**PROJECT NO. CP 24-20 TULSA ZOO RAINFOREST HVAC /
ELECTRICAL UPGRADES**

ADDENDUM NO. 3
TO
PROJECT NO. CP 24-20 TULSA ZOO
RAINFOREST HVAC / ELECTRICAL UPGRADES

ADDENDUM NO. 3

This Addendum address revisions to owner furnished equipment as part of add alternate 2 and additional HVAC dampers.

SHEET	OF	31	SHEET NO.	G002
-------	----	----	-----------	------

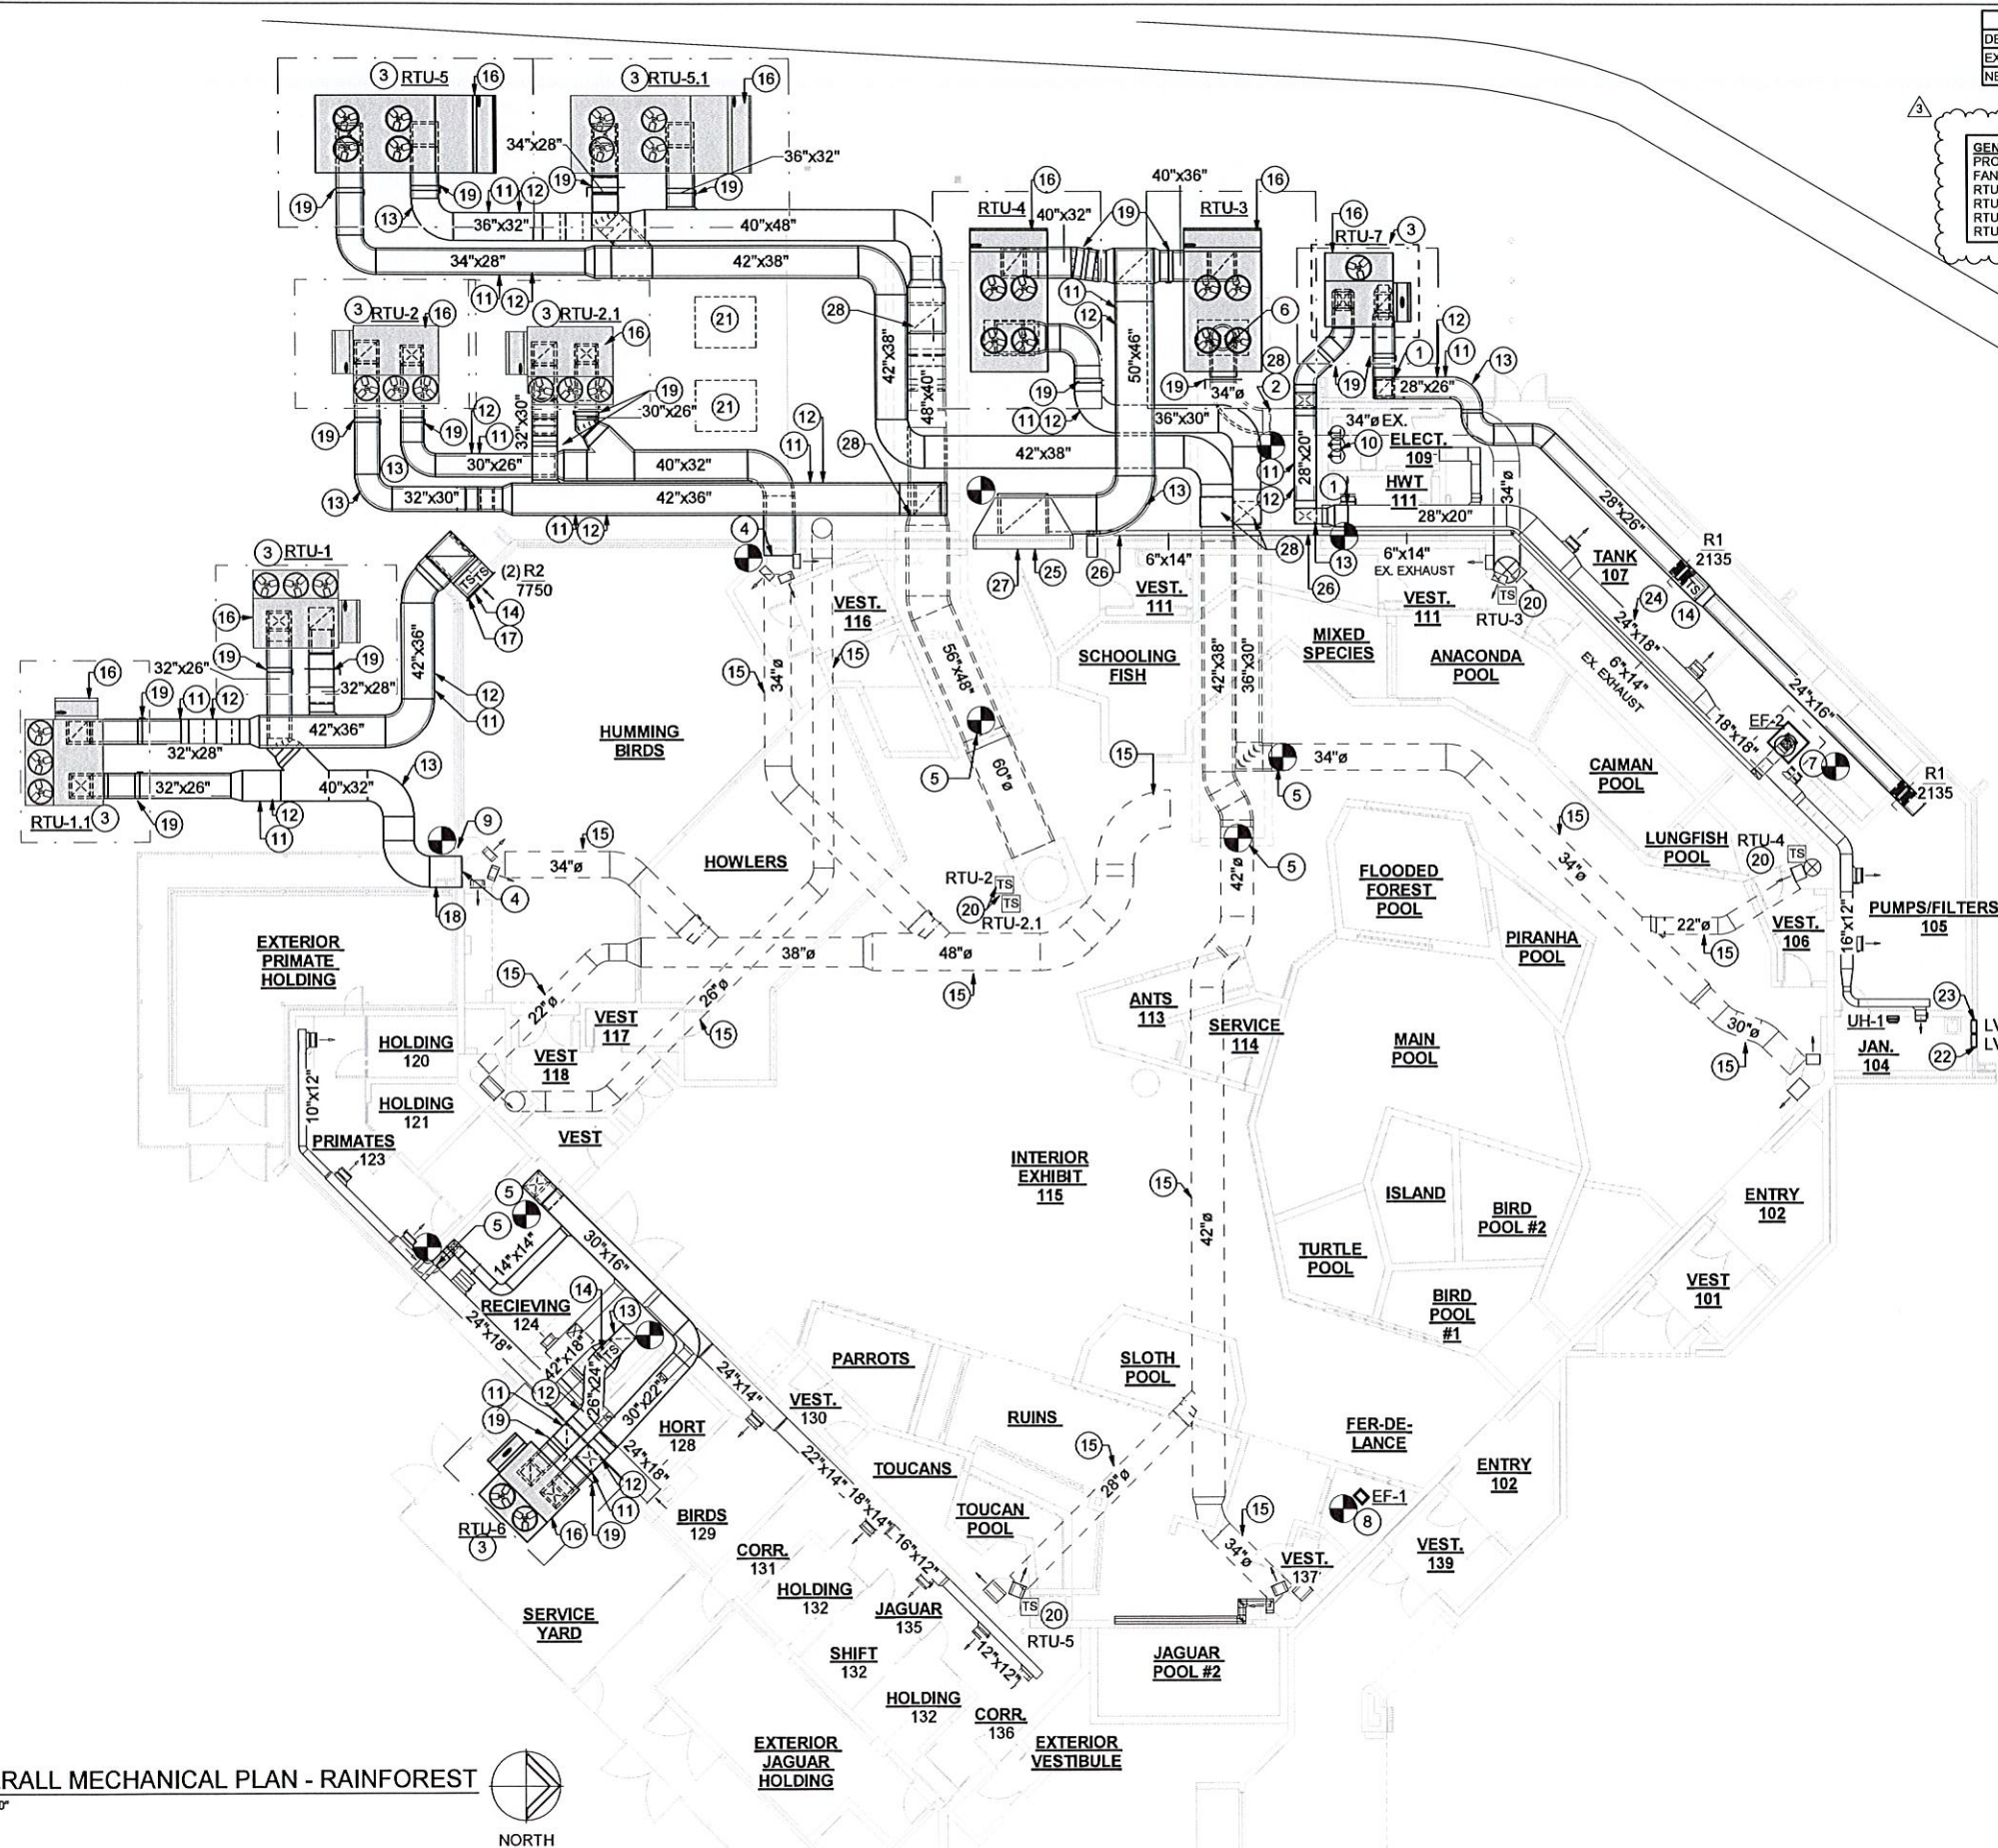
Reference sheet G002;

1. Revised add alternate 2 and renumbered bid items under alternate 3.
